# **Bell Bend Nuclear Power Plant**

## **Combined License Application**

### **Part 4: Technical Specifications**

## Part 4 - Technical Specifications and Bases

[Figure 3.7.16-1 \(page 1 of 1\)](#)

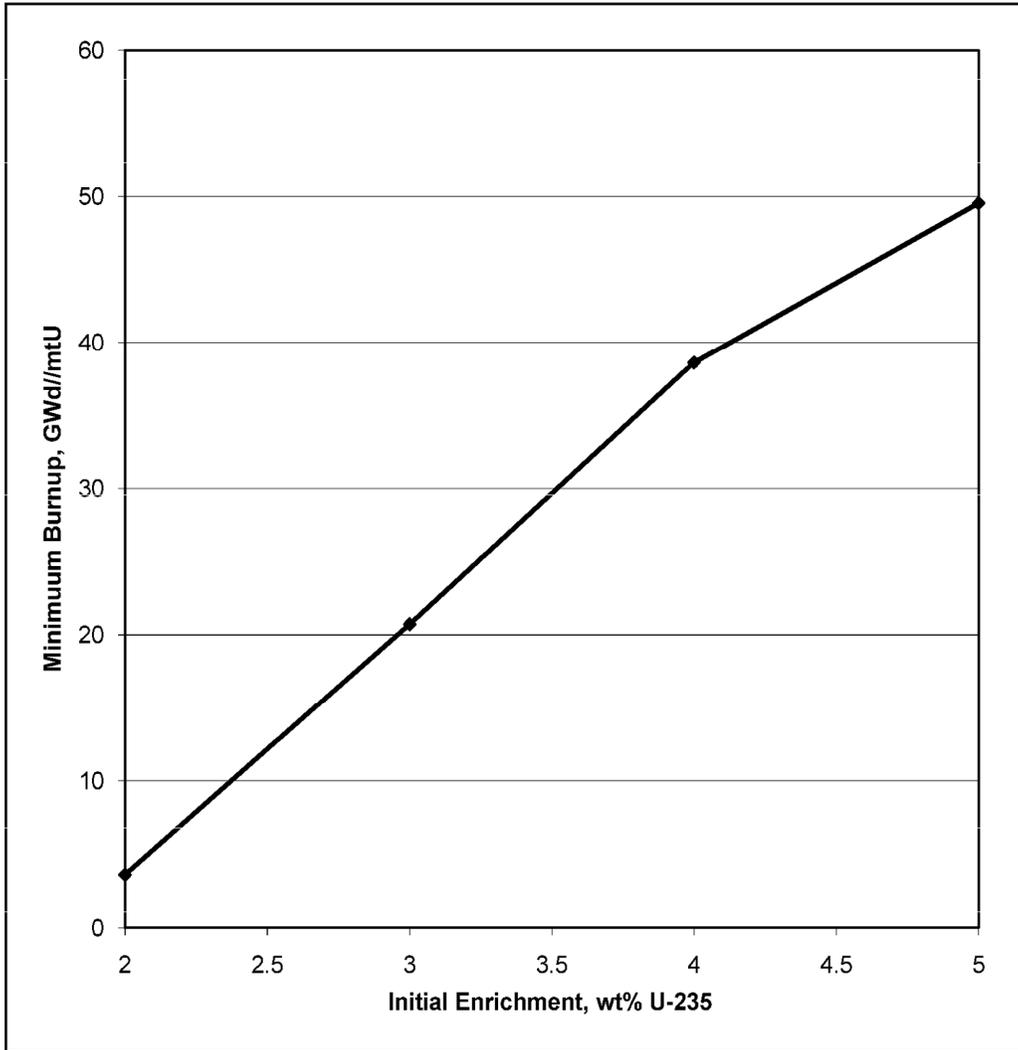
{BBNPP} TS and Bases 3.7.16, "Spent Fuel Storage," are revised to remove the Reviewer's Note and include the {BBNPP} specific spent fuel storage requirements in the TS and Bases, including the addition of Figure 3.7.16-1, "Fuel Assembly Burnup Requirements for Region 2." The associated Bases (all

LCO 3.7.16 ~~Fuel shall be stored in approved locations in the spent fuel storage pool~~  
The combination of initial enrichment and burnup of each fuel assembly stored in Region 2 of the spent fuel storage pool shall be within the limits specified in Figure 3.7.16-1.

SURVEILLANCE	FREQUENCY
<p>SR 3.7.16.1 Verify by administrative means <del>that fuel assemblies are stored in approved locations</del><u>the initial enrichment and burnup of the fuel assembly is in accordance with Figure 3.7.16-1.</u></p>	<p>Prior to storing the fuel assembly in <u>Region 2 of</u> the spent fuel storage pool</p>

The {BBNPP} specific TS and Bases 3.7.16 are revised to reflect the results of the design and analyses of the {BBNPP} specific spent fuel racks described in the Holtec Topical Report for the design and analyses of the U.S. EPR spent fuel storage racks.

Figure 4.3-1 (page 1 of 1)

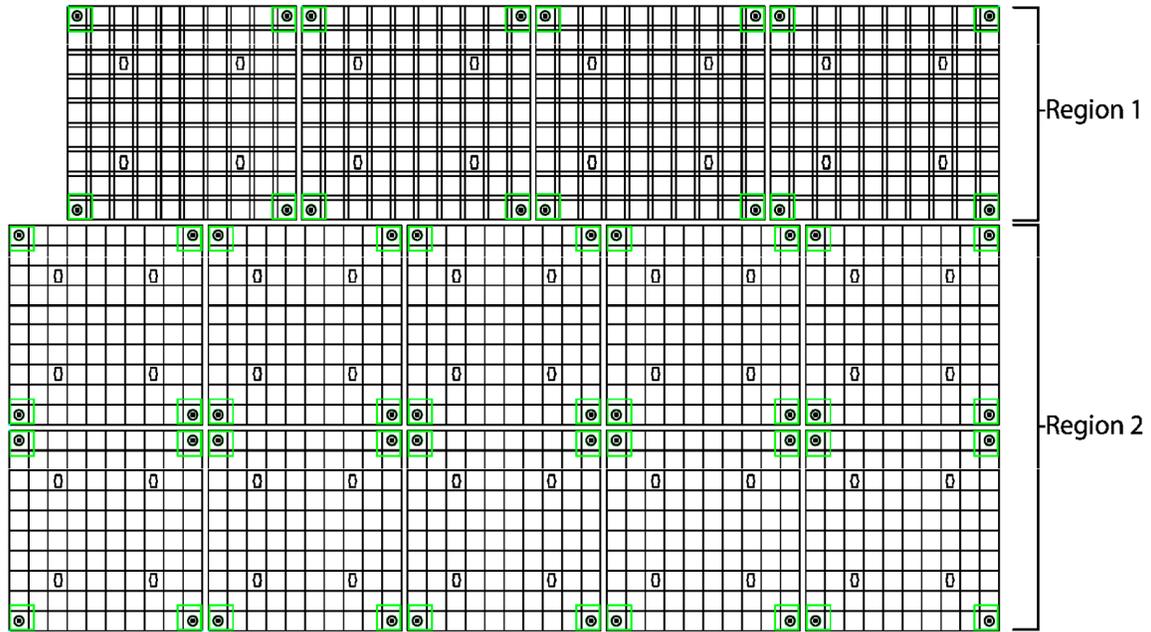
{BBNPP} TS 4.3.1.1.c is revised to include the spent fuel rack center to center distances between fuel assemblies stored in Region 1 and for fuel assemblies stored in Region 2 of the {BBNPP} spent fuel racks. In addition, restrictions on the storage of fuel assemblies are established in TS 4.3.1.1.d and 4.3.1.1.e. Figure 4.3-1, “Discrete Two Region Spent Fuel Storage Pool Rack Layout” is added to identify the storage cells associated with Region 1 and the storage cells associated with Region 2.

d. New or partially spent fuel assemblies with any discharge burnup may be allowed unrestricted storage in Region 1 of Figure 4.3-1;

e. Partially spent fuel assemblies meeting the initial enrichment and burnup requirements of LCO 3.7.16, "Spent Fuel Storage," may be stored in Region 2 of Figure 4.3-1.

{BBNPP} specific TS 4.3.1.1 requirements are revised to reflect the results of the design and analyses of the {BBNPP} specific spent fuel racks described in the Holtec Topical Report for the design and analyses of the U.S. EPR spent fuel storage racks.
